# H11629

#### DESCRIPTIVE REPORT

Registry No. H11629

General Locality Perdido Bay

Figure 3- Survey limits of H-11629 showing six uncharted features identified by the 2007 survey. ENC US5AL12M,  $10^{\rm th}$  Edition.

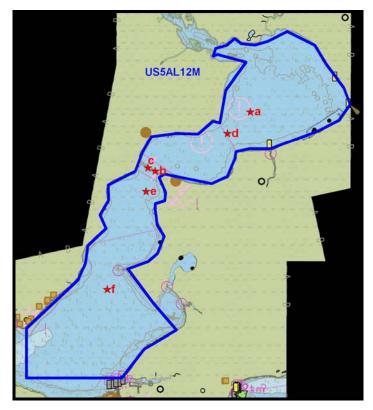
The 2007 survey identified six features which are not currently charted. A detailed description of the feature is contained in Table 1 and Figure 4. The hydrographer recommends updating the ENC with data from the 2007 survey. *Concur.*

Feature Letter	Latitude N	Longitude W	Sounding Value (m)	ENC	Comment
а	30.4271536 30°25'37.753"	87.3858986 87°23'09.235"	1.1	US5AL12M, 10th Edition	Add OBSTN  Do Not Concur. Delete charted 3 ft obstn (Rep 2007). See PYDRO Report for details.
b	30.4038997 30°24'14.0389"	87.4285033 87°25'42.6119"	1.5	US5AL12M, 10th Edition	Add OBSTN  Do not concur. Not submitted as a danger. Update chart with present survey sepths.  See Evaluation Report Secton D.1.1.9. for details.
С	30.4052089 30°24'18.75"	87.4317205 087°25′54.19″	0.5 1.975	US5AL12M, 10th Edition	Add OBSTN Concur with clarification. Revise to dangerous 6 ft. obstn See PYDRO Report for details.
d	30.4186983 30°25'07.3139"	87.3961556 087°23'46.1602"	<del>0.7</del>	US5AL12M, 10th Edition	Add OBSTN  Do not concur. Delete 2 ft dang obstn (Rep 2007) See PYDRO Report for details.

Feature Letter	Latitude N	Longitude W	Sounding Value (m)	ENC	Comment
е	30.3959705 30°23'45.4938"	87.432557 087°25'57.2052"	<del>0.6</del>	US5AL12M, 10th Edition	Add OBSTN  Do not concur. Delete 2 ft dang obstn (Rep 2007) See PYDRO Report for details.
f	30.3578192 30°21'28.1491"	87.4497941 087°26'59.2588"	1.7	US5AL12M, 10th Edition	Add OBSTN Concur with clarification. Feature is currently charted as 5-ft Obstn (Rep 2007). Revise to 5-ft dang obstn.

Figure 4- Survey limits of H-11629 showing two locations the 2007 survey soundings are significantly shoaler than the soundings charted on ENC US5AL12M, 10<sup>th</sup> Edition.

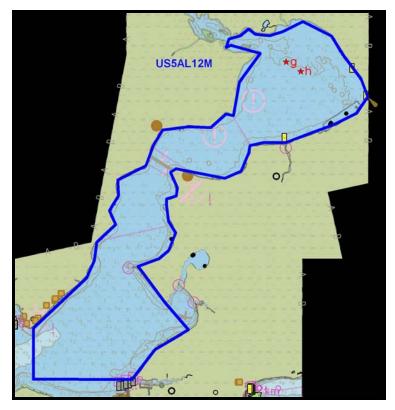
Survey depths are in general agreement with the charted depths for the largest scale ENC covering H-11629. There are two soundings on the ENC which are recommended for update by the hydrographer. *Concur with clarification*. *Update chart with present survey data*.

Feature Letter	Latitude N	itude N Longitude W		ENC	2007 Sounding Value (m)
g	30.443113 <b>30°26'35.2068"</b>	87.3766776 <b>087°22'36.0394"</b>	2.1	US5AL12M, 10th Edition	<b>1.8 -</b> 1.9
h	30.4395361 <b>30°26′22.33″</b>	87.3703304 <b>087°22'13.1894"</b>	2.1	US5AL12M, 10th Edition	<del>1.9</del> <b>1.8</b>

Figure 5 - Survey limits of H-11629, showing the 1.8m (green), 3.6m (red), and 5.4m (blue) 2007 survey contours. ENC US5AL12M,  $10^{\rm th}$  Edition.

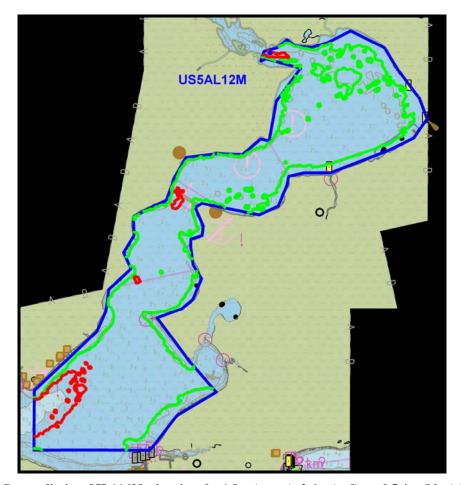
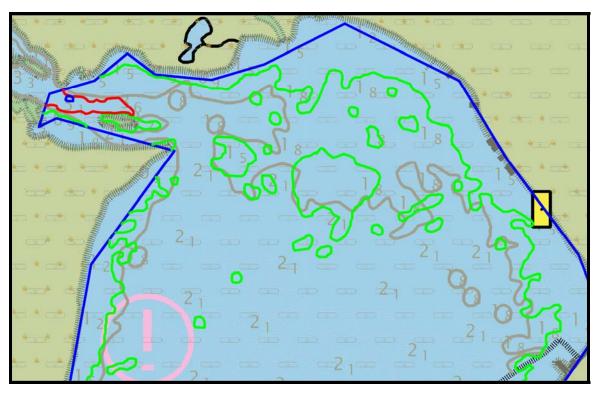
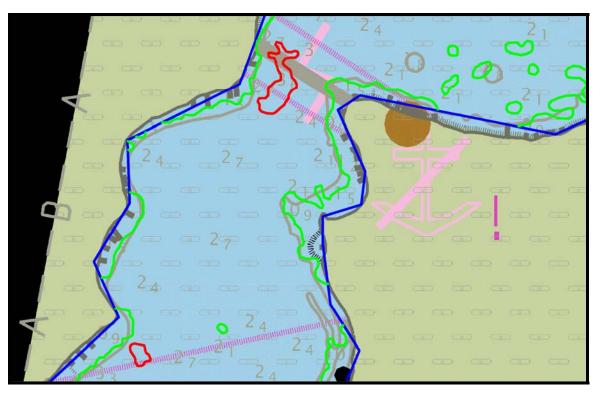
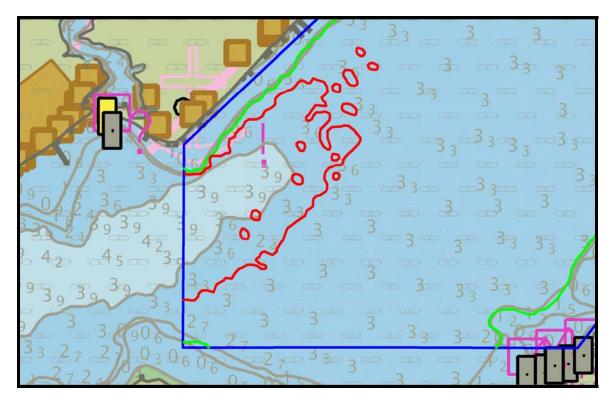
The 2007 survey data were used to create depth contours for comparison with charted contours (Figure 5). The location of the 1.8m contour which follows the shoreline remains consistent with the currently charted contour on ENC US5AL12M, 10th Edition, except where the Perdido River feeds into the Perdido Bay. The 2007 survey data indicate that the river channel has deepened and widened into the north side of the bay (Figure 6); therefore, the hydrographer recommends updating the 1.8m contour to reflect the migration. Underneath the Lillian Bridge, the channel on the west side of bottlenecked bridge has deepened (Figure 7). Additionally, to the south end of the survey, near Perdido Beach, the channel through the lower bottleneck of Perdido Bay has

lengthened and widened northward (Figure 8). The hydrographer recommends updating the contours in these locations. *Concur*

Figure 1.2.1

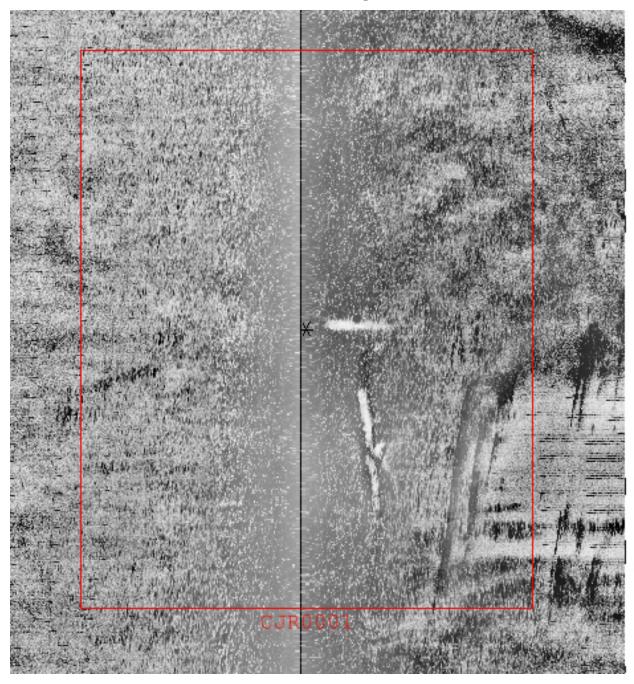
Chart a one foot dangerous obstruction at the given location.

Concur with clarification. Cat an dangerous 6 foot obstruction in the present survey locaiton. The least depth comes from C3D data and is not documented as such. No data point is represented in the submitted grid. No grid was submitted for the C3D data as it was not edited. AHB was required to edit the data within the common area to find the feature and reference the source data.

Figure 1.5.1

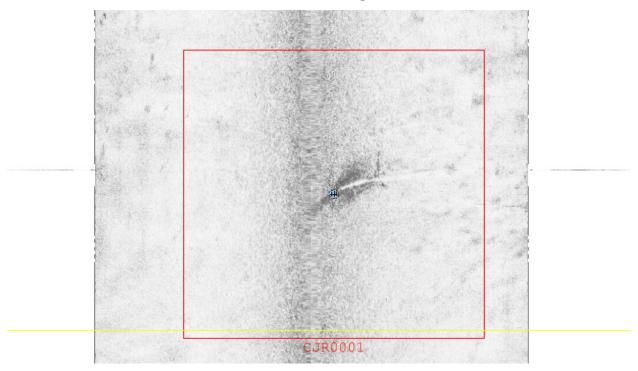
Chart a 5 ft dangerous obstruction at the given location.

Concur.with clarification Chart a 5 foot dangerous obstruction at the present survey location.
